Project: Wayfinding Signage Program

Date: March 20, 2017

RE: Addendum # 5
of Pages: (7)

The following information is provided in response to written questions received in connection with the Battery Park City Authority (“BPCA”) Request for Proposals (“RFP”) issued on January 18, 2017 for its “Wayfinding Signage Program” project (the “Project.”)

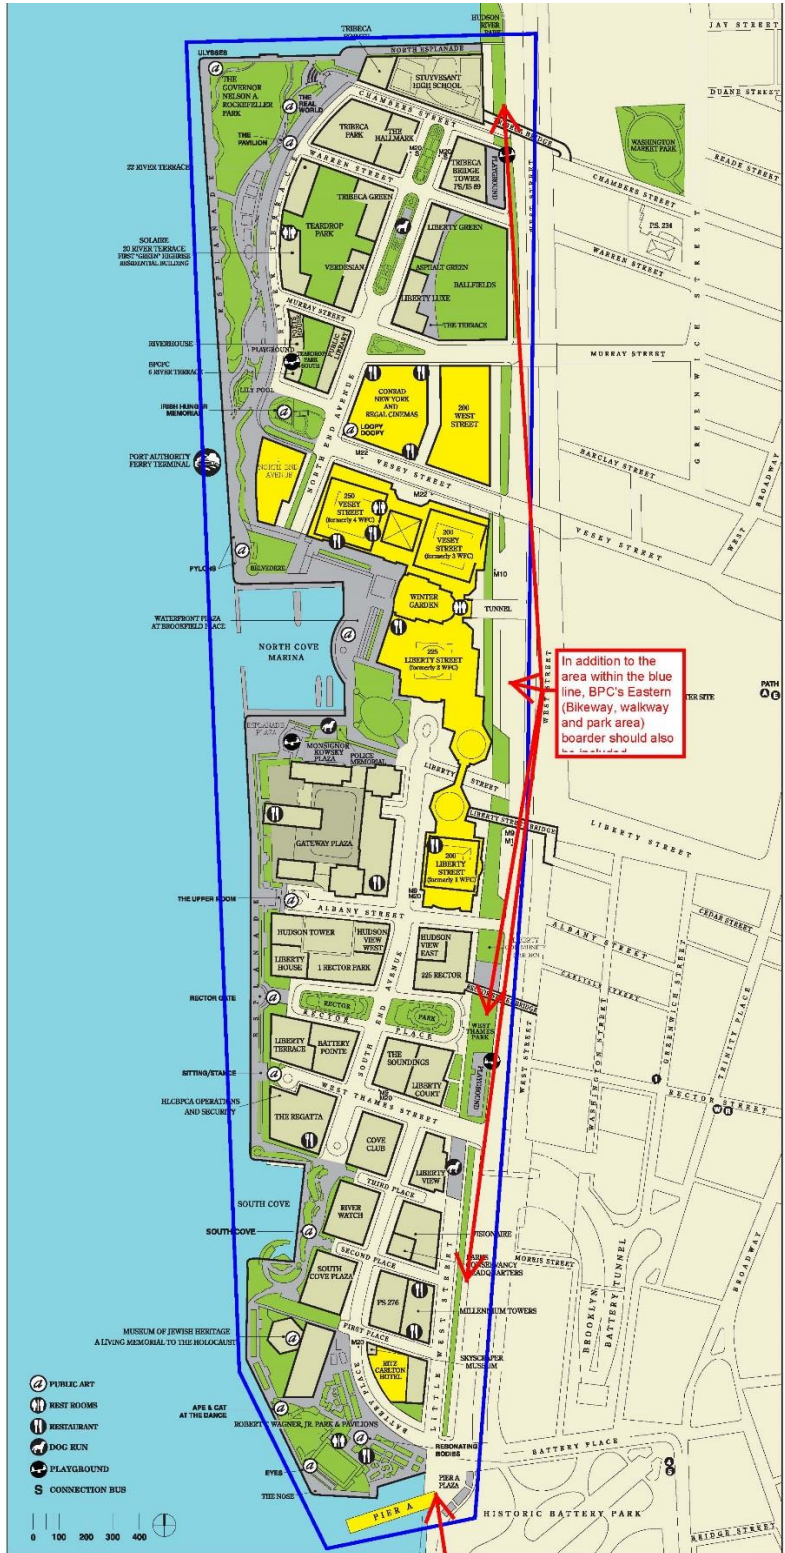
31. Please provide clarification with respect to the physical geographic boundaries (North, East, South, West street borders and/or a map or diagram showing the area) that should be considered within the scope of this project.

Response: *A diagram of the project area is attached on the following page.*

In addition to the area within the blue line, BP's Eastern (Bikeway, walkway and park area) border should also

Pier A and the Plaza is included
